PROJECT TITLE
Royal Northern College of Music

DRAWING TITLE
East & West Elevations
Existing & Proposed

DRAWING NO.
PR1-IPA- Z1-18_4-GA-A-200505

2 East Elevation_Proposed Phase 18-4
1 : 100

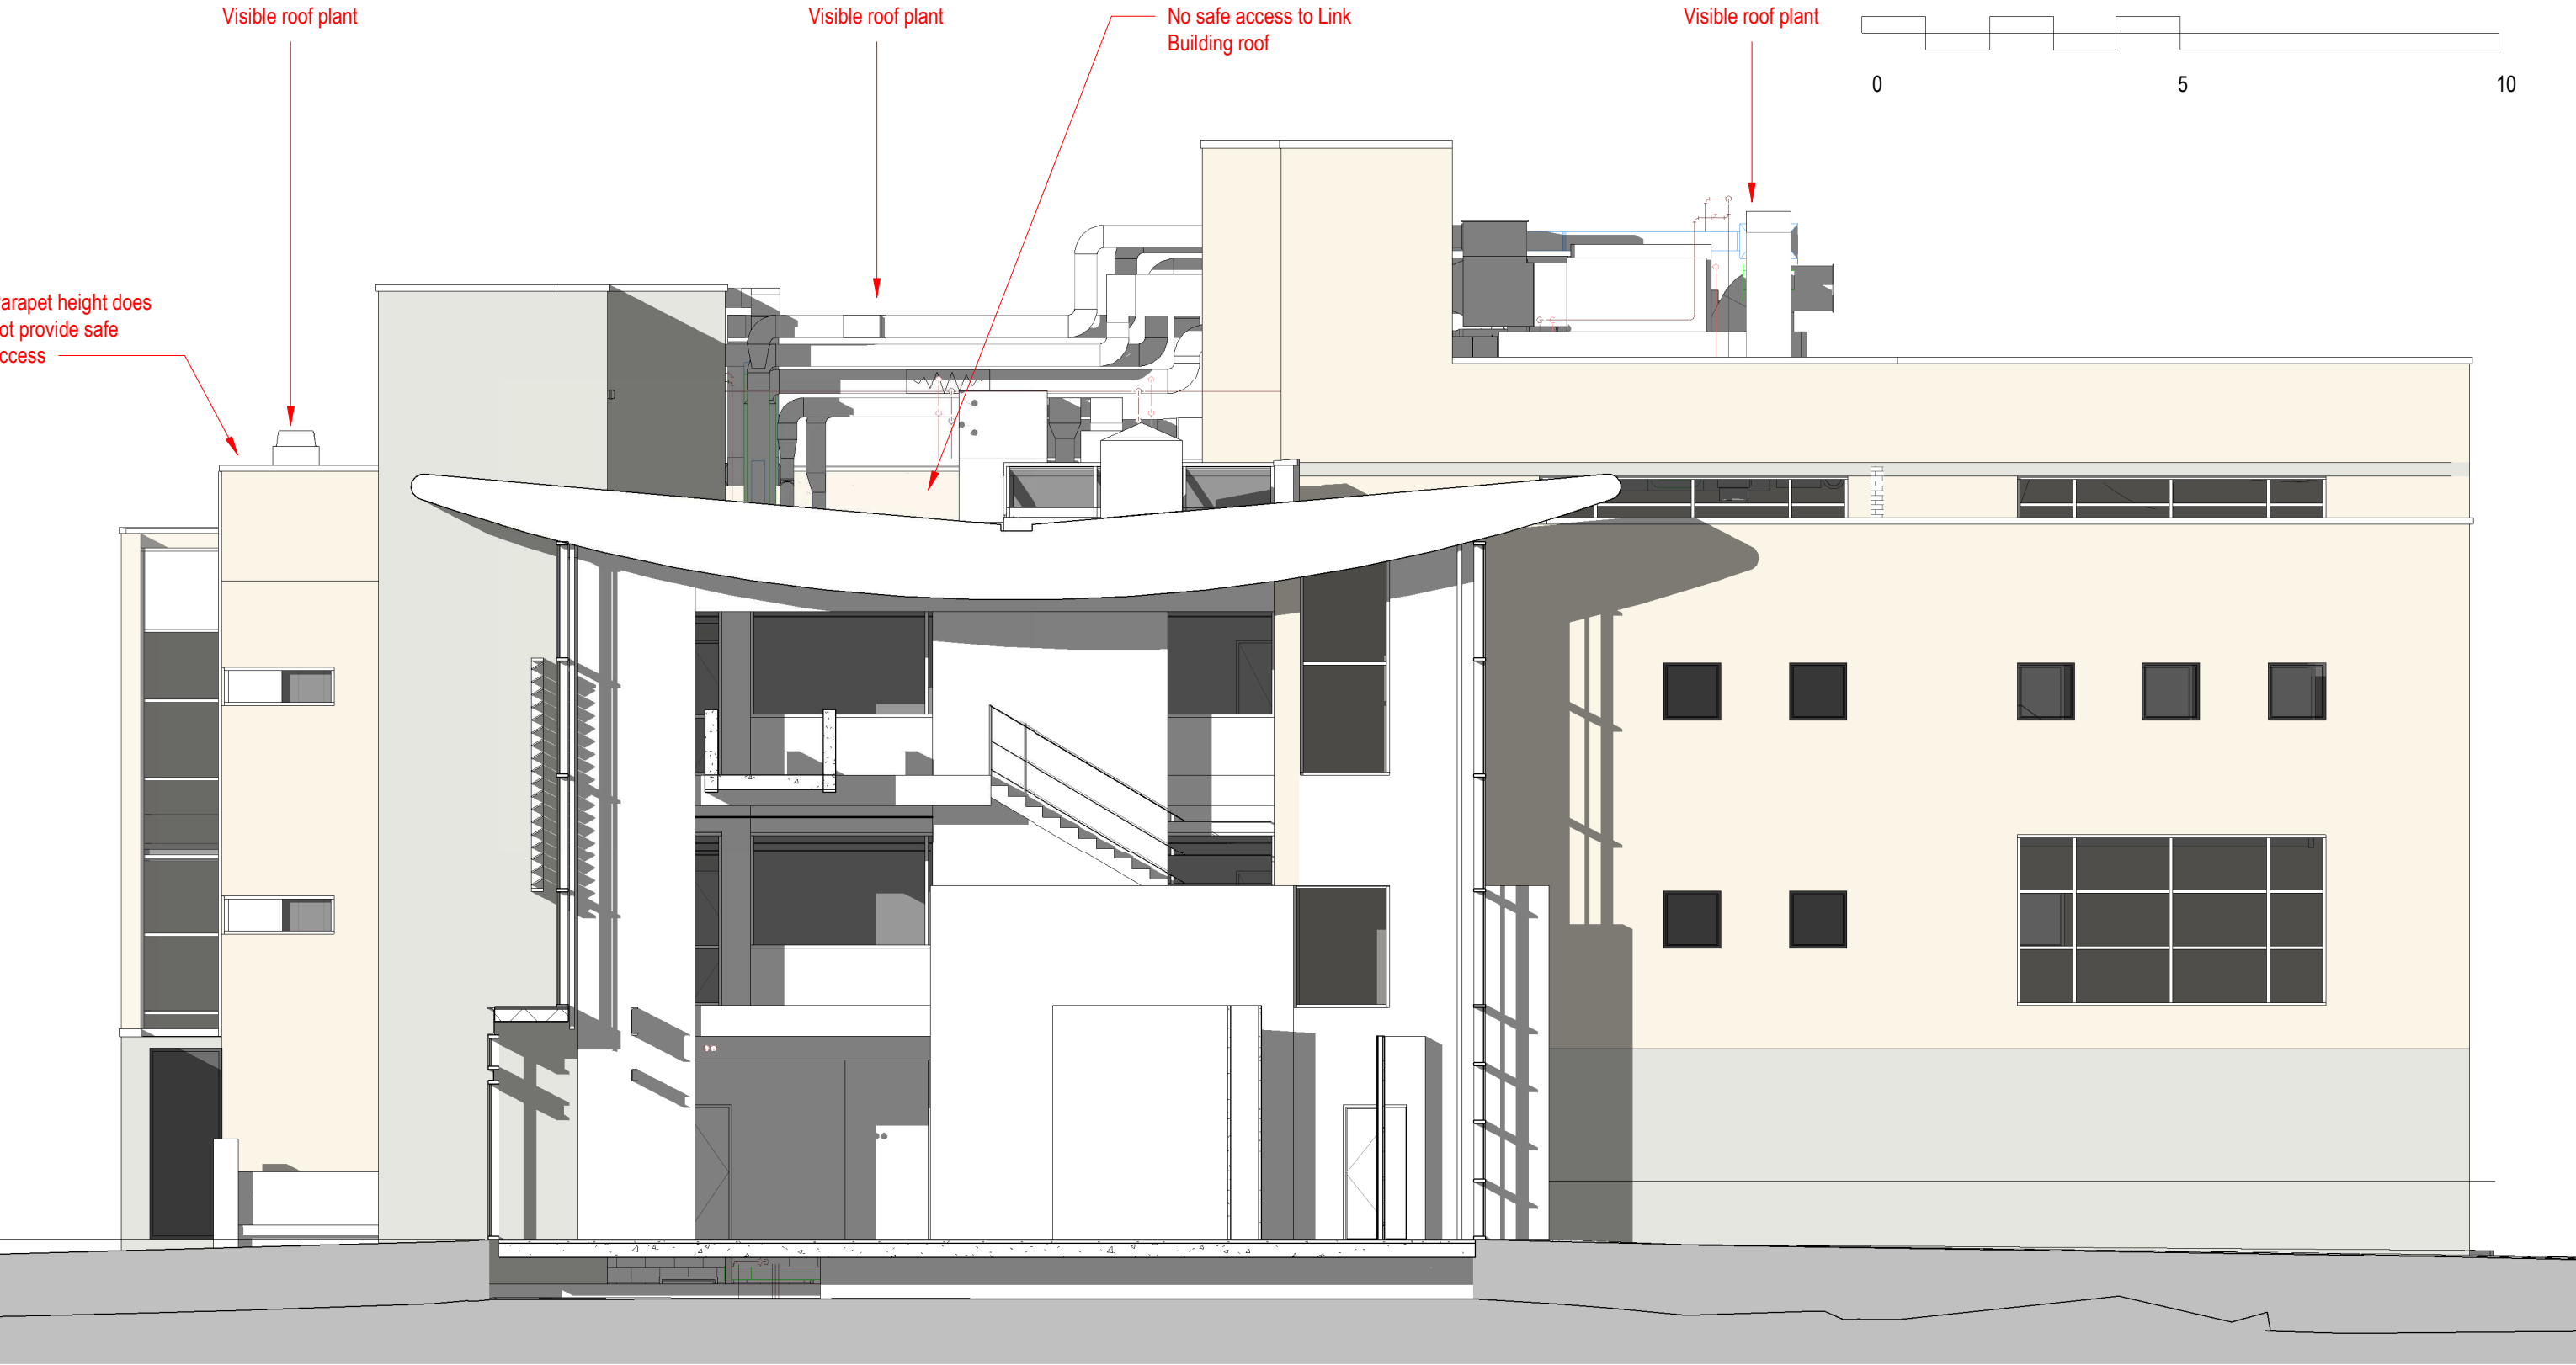
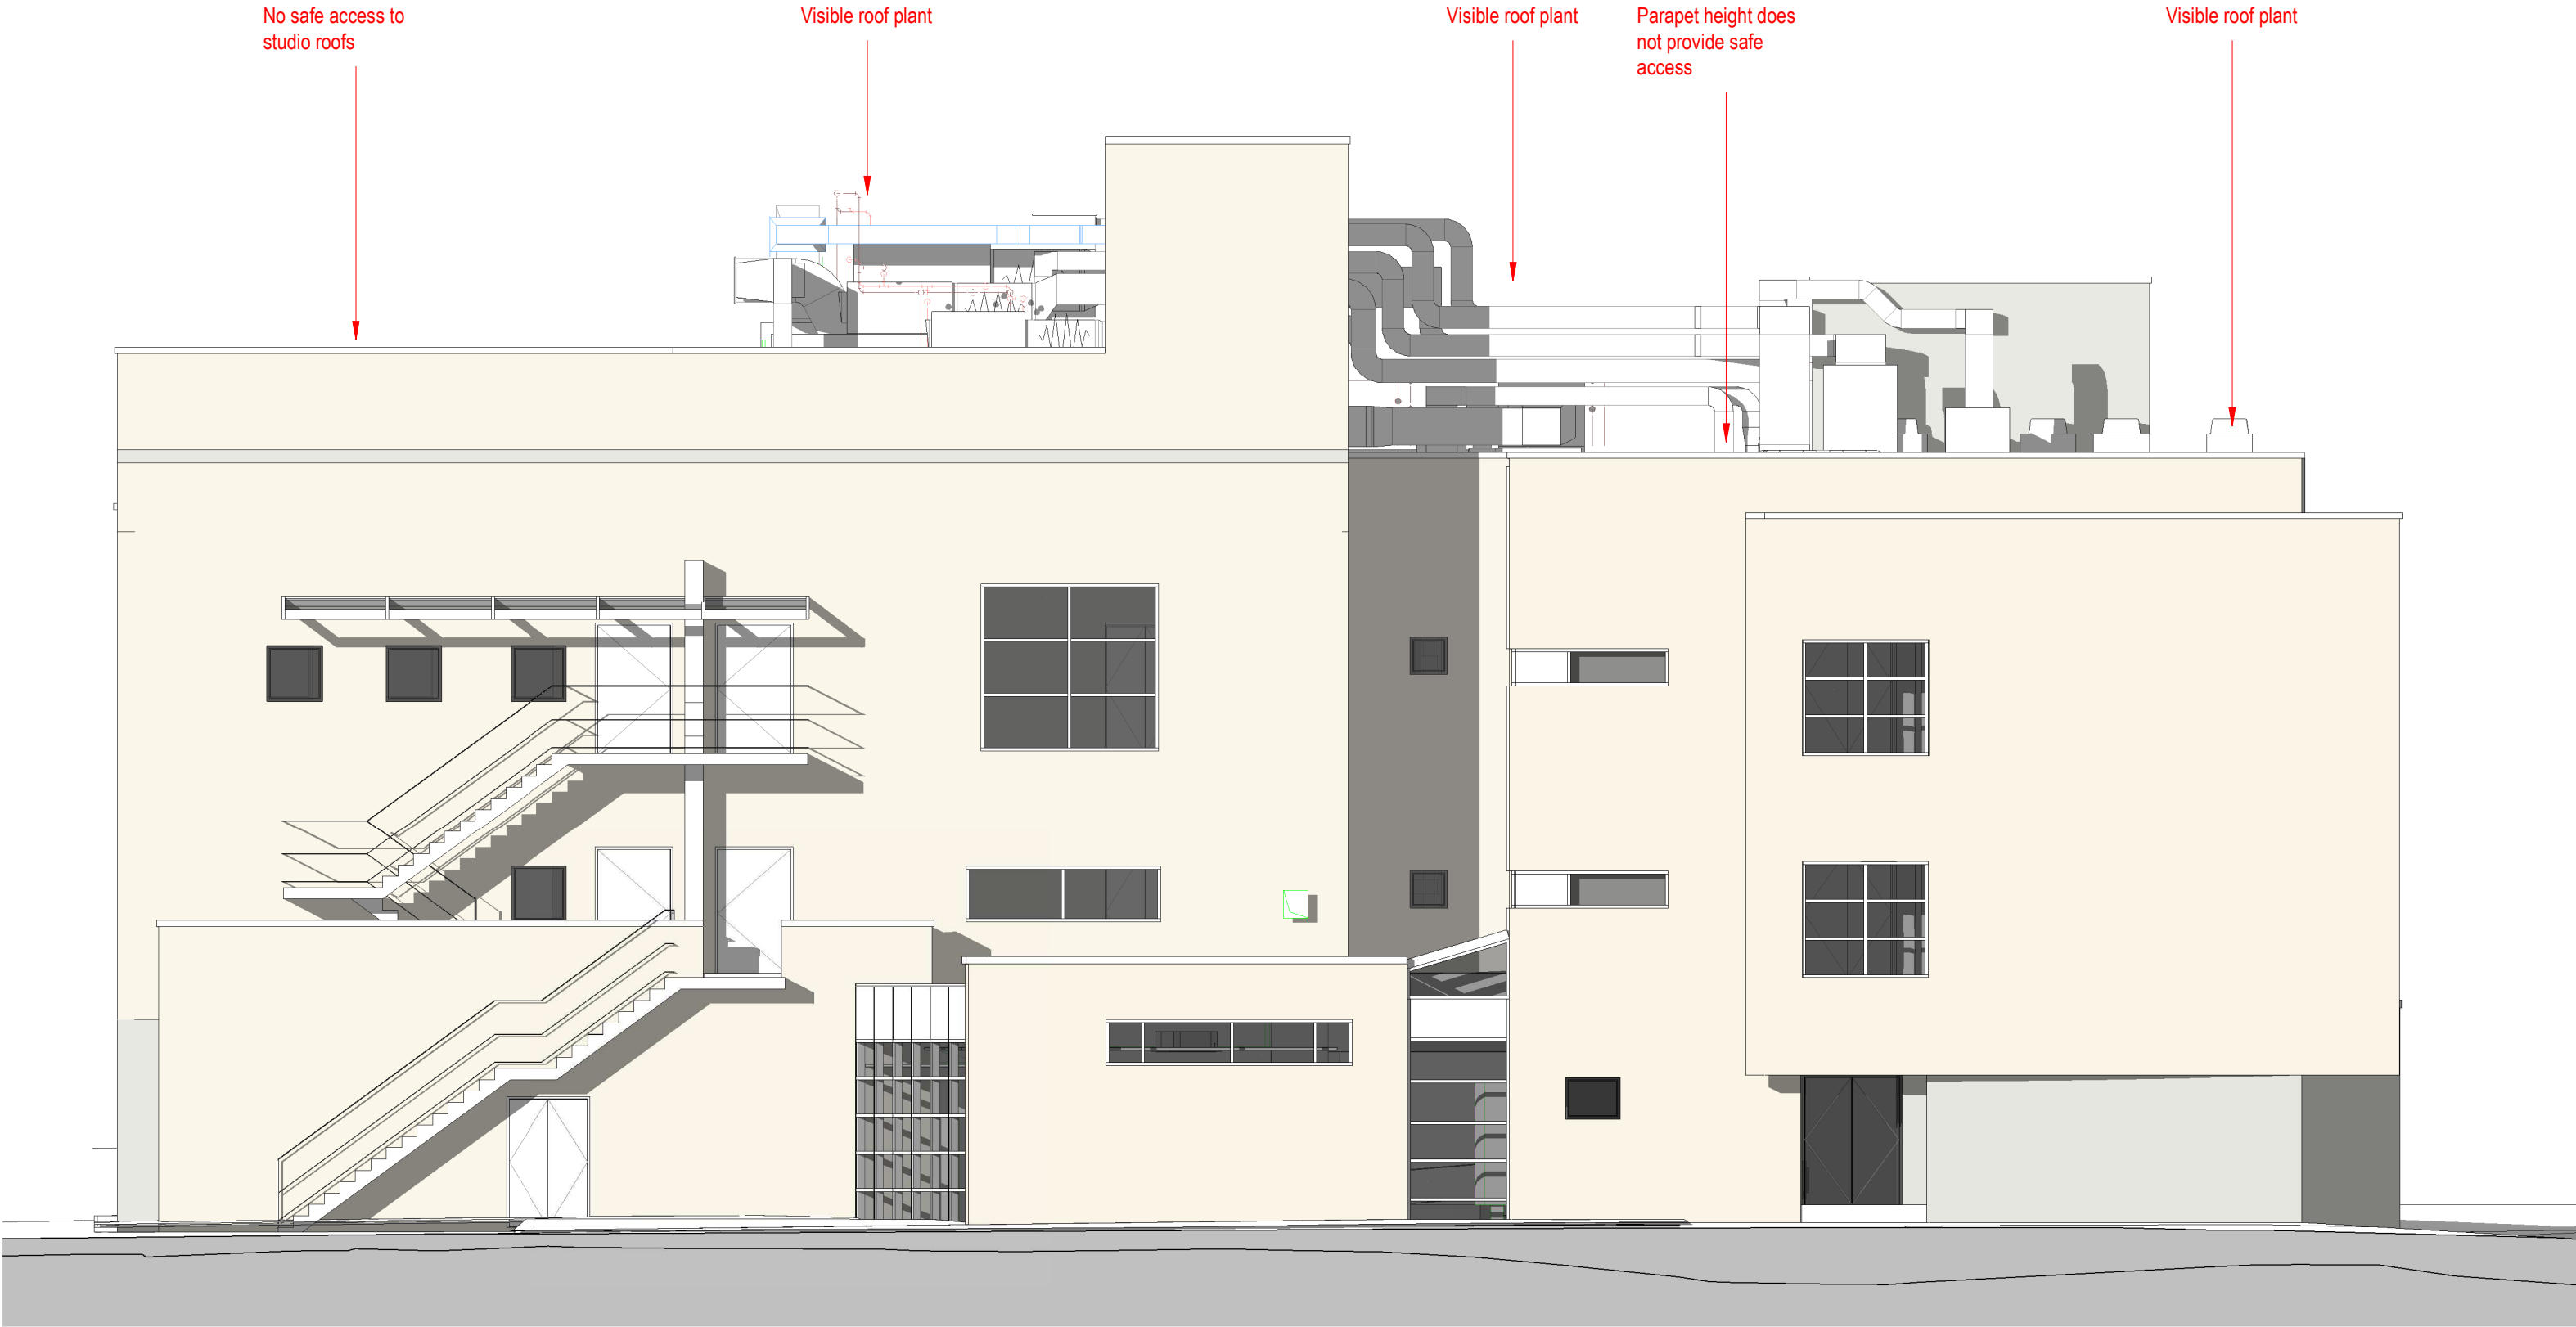
Roof light replaced - lower pitch required to accommodate roof overlay thickness.
Ref to Z1-00-SK-A-001 & 002
